**SUBJECT: R.E. Ginna Nuclear Power Plant**  
Docket No. 50-244

**Response to NRC Generic Request for Additional Information Regarding  
Relaxed Axial Offset Control, R.E. Ginna Nuclear Power Plant (TAC No.  
MC6867)**

**RESPONSE TO NRC REQUEST FOR ADDITIONAL INFORMATION  
REGARDING RELAXED AXIAL OFFSET CONTROL, R.E. GINNA  
NUCLEAR POWER PLANT**

Figure 1 ( $F_Q$  Results from Most Limiting Representative LP)

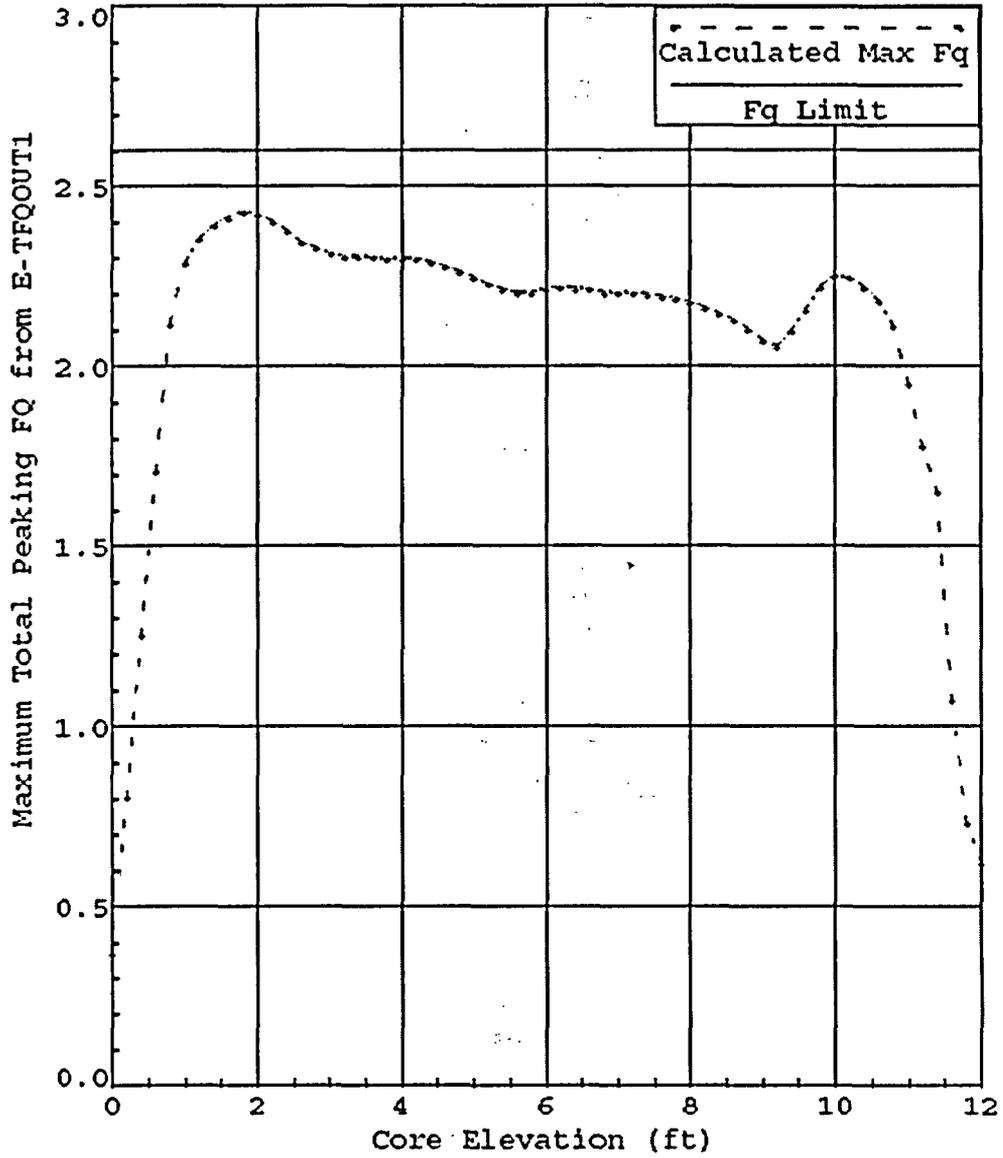
**Provide the results of the  $F_Q$  analysis (i.e., the permissible  $F_Q$  and the  $W(Z)$  function).**

As described in the response to RAI #1, the analysis performed for Ginna was based on representative uprated loading patterns, and a specific reload analysis will be performed for each reload to check the applicable limits. The requested results from the most limiting representative loading pattern studied for Ginna are shown in Figures 1 and 2. These results correspond to the typical AFD band limits identified in the response to RAI #1. The maximum transient  $F_Q$  result for the limiting representative cycle was 2.432, compared to a LOCA limit of 2.60. These results only confirm the viability of the methodology and should not be used as a defining basis for NRC approval. As described in the 29 April 2005 application, the actual determination of the permissible  $F_Q$  and the  $W(Z)$  values is performed for each reload cycle.
